667A - Piper

(This supersedes and voids Piper Service Letter No. 667, dated November 12, 1973.)

Piper Aircraft Corporation
Lock Haven, Pennsylvania, U.S.A.

Stabilator Attachment Bolts

SKETCH

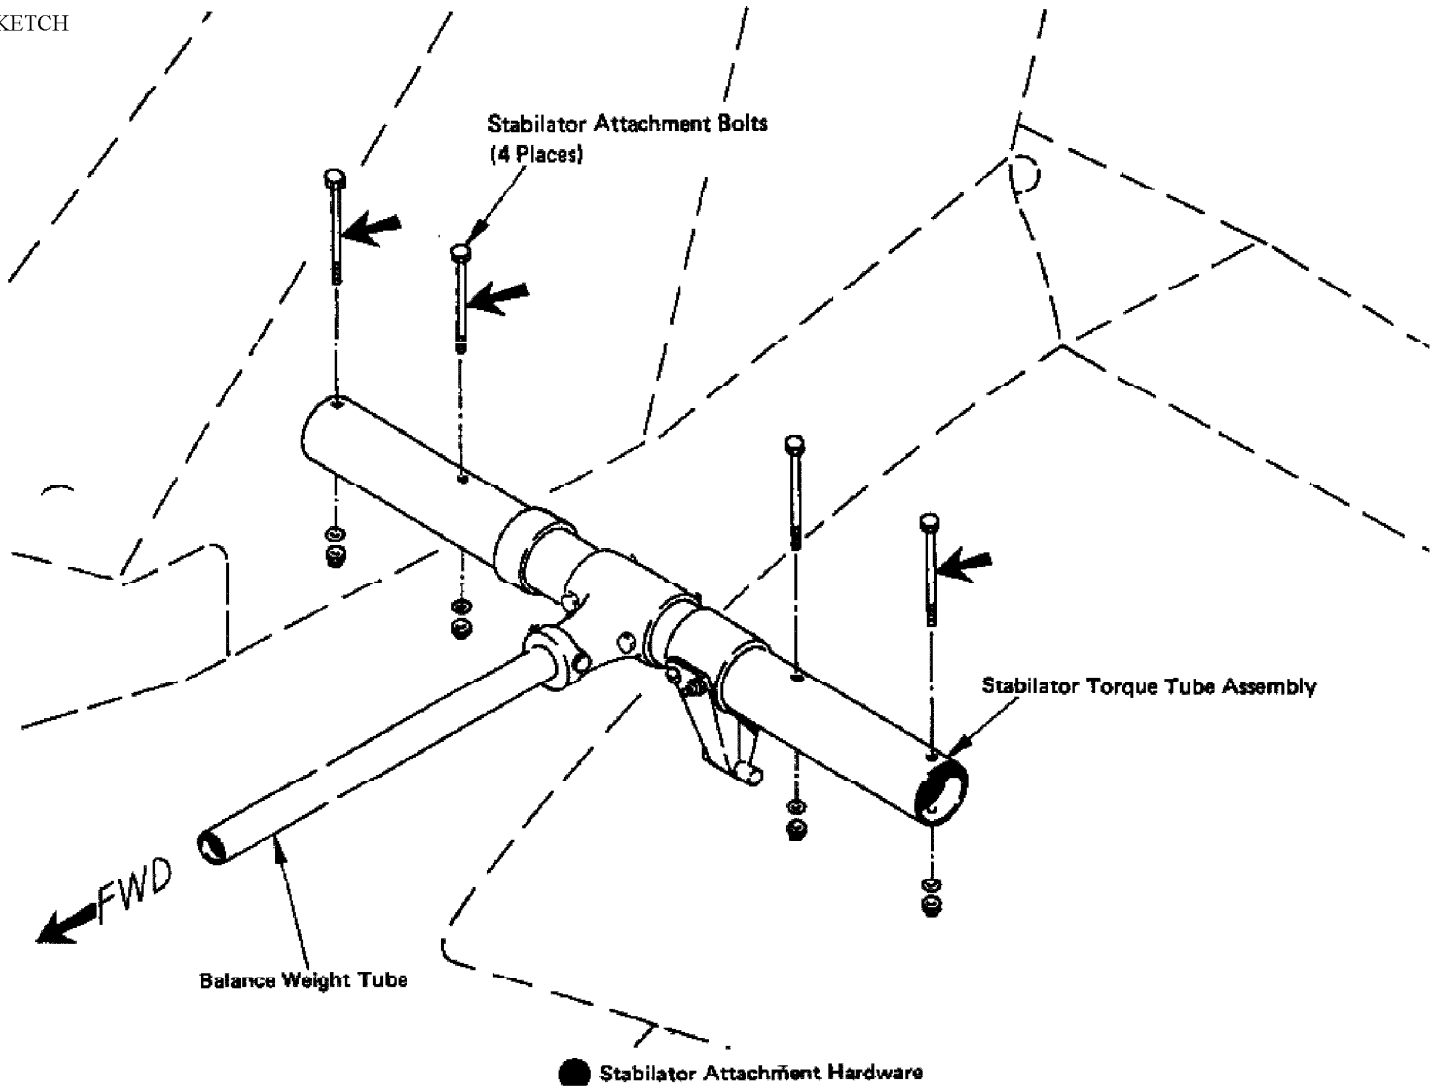
1. Remove existing stabilator attachment bolts, washers and nuts, indicated on sketch, and install new bolts and attaching hardware.

Remove and replace one bolt at a time. Refer to sketch for correct replacement hardware identification and proper assembly of bolts, washers and nuts.

- a. PA-24-180/250 and 260 - torque to 30-40 inch lbs.
- b. PA-23-235/250/250 (Six Place) and PA-24-400 - torque to 60-85 inch lbs.
- c. Pa-30 - Refer to the Twin Comanche Service Manual (Section 4 - paragraph 49) which states that the nuts ("holding the stabilator to the torque tube") should "be tightened just enough to take the play out of the washers."

PA-24-180/250 and 260 only

Bolt AN174-C32A P/N 502 329 (Corrosion Resistant) or Bolt AN174-32A P/N 402 342 (Non-Corrosion Resistant)
 Washer AN960-416L P/N 407 585
 Nut MS20365 428C P/N 404 888

PA-23-235/250/250 Six Place, PA-24-400 and PA-30 only

Bolt AN175-C32A P/N 502 342 (Corrosion Resistant) or Bolt AN175-32A P/N 402 342 (Non-Corrosion Resistant)
 Washer AN960-516 P/N 407 566 (PA-23-235/250 and 250 Six Place only)
 Washer AN960-516L P/N 407 586 (PA-24-400 and PA-30 only)
 Nut MS20365-524C P/N 404 889
